# **Environmental Assessment for the Accelerated Tank Closure Demonstration Project**

Prepared by:  
U.S. Department of Energy  
Office of River Protection  
Richland, Washington

RESPONSE TO COMMENTS ON ENVIRONMENTAL ASSESSMENT DOE/EA-1462 FOR THE ACCELERATED TANK CLOSURE DEMONSTRATION PROJECT

**State of Washington Department of Ecology Comments and Department of Energy  
Response on the ATCD Project Draft EA DOE/EA-1462**

Figure 2-1. Location Map of WMA C and Surrounding Facility

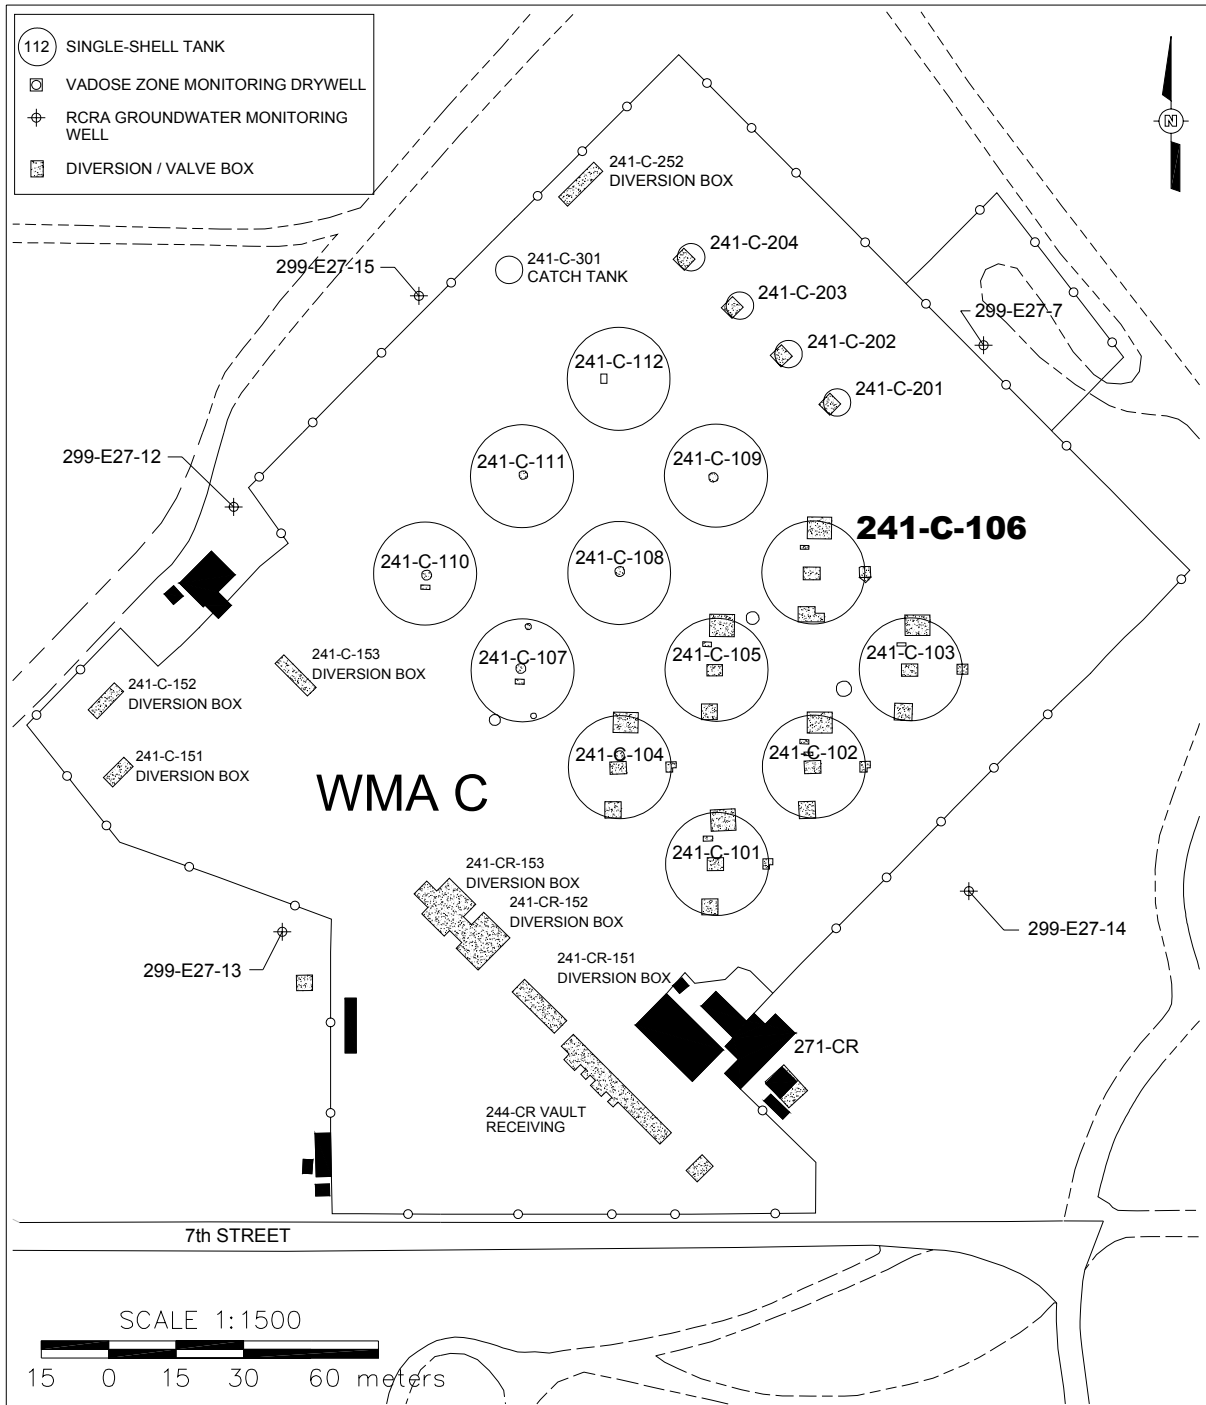
**Comment 6:**

A map (Figure 2) has been added to the final EA to illustrate the C tank farm layout.
